REMARKS

The present Response is submitted in response to the Official Action of June 20, 2007.

10/550,231

Fig. 1

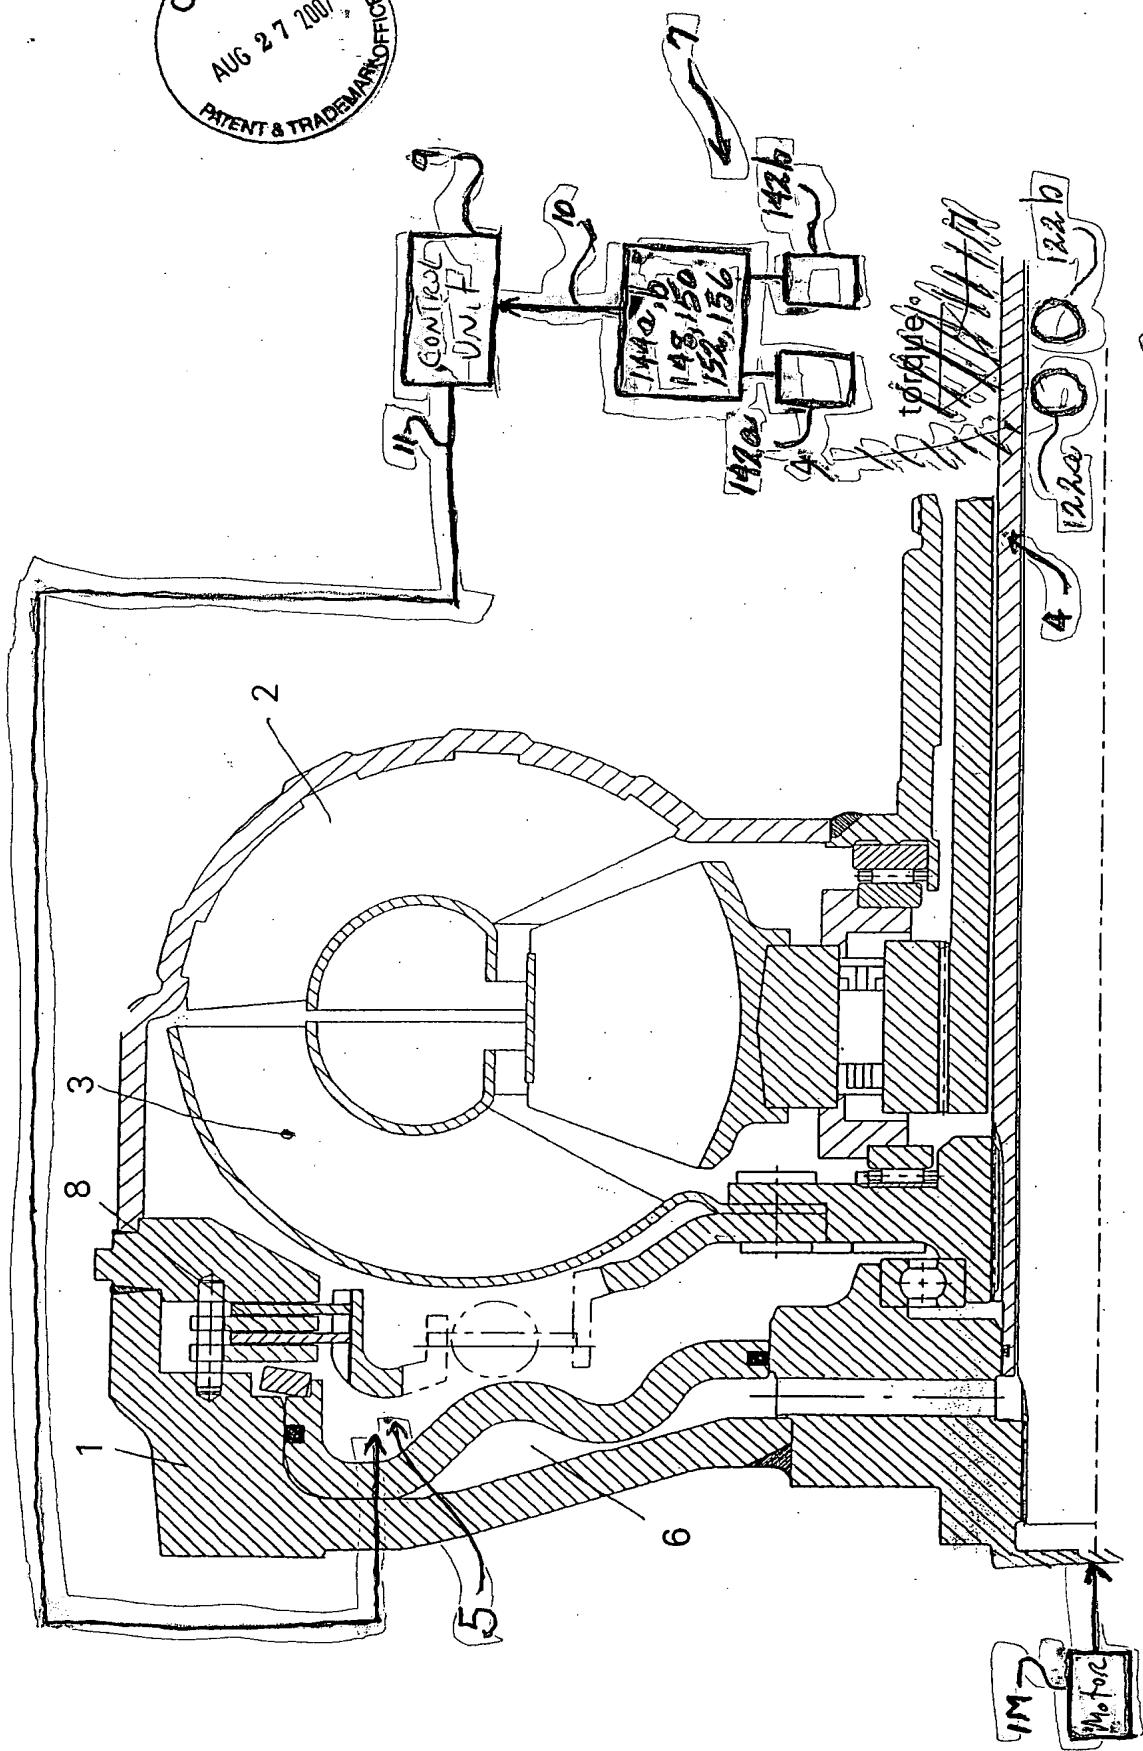
The Examiner objects to the drawings, under 37 CFR 1.83(a), as not showing the torque measurement device fitted directly on or in the turbine rotor as recited, for example, in claims 15 and 20. In a related claim rejection, claims 15 and 20 are rejected, under 35 U.S.C. § 112, first paragraph, as reciting subject matter not disclosed in the specification, again referring to the torque measurement device fitted directly on or in the turbine rotor.

Further according to the present invention as recited in the claims as amended, the torque signal is then provided to an electronic control unit, now shown as element 11 in amended FIG. 1 which, in turn, controls a continuously variable slippage of the clutch 8 to control the torque transferred through the torque converter to the drive output shaft 4 to a specified value.

It is further the Applicant's belief and position that the incorporation by reference of some of the associated teachings and descriptions of the magnetic transducer according to WO 01/96826 A2 into the specification of the present Application, based on paragraphs [011], [013], [020] and [021], satisfies the requirements of 37 CFR 1.83(a). Notwithstanding this, in order to advance prosecution of the present Application and in order to formalize the material incorporated by reference, the drawings of this application are amended to include FIGS. 1 and 22 of WO 01/96826 A2 (now FIGS. 1B and 1C, respectively), but these new Figures are appropriately marked as prior art. New Replacement Sheets of formal drawing(s), accompany

this Submission and incorporate all of the described drawing amendments. If any further amendment to the drawings is believed necessary, the Examiner is invited to contact the undersigned representative of the Applicant to discuss the same.
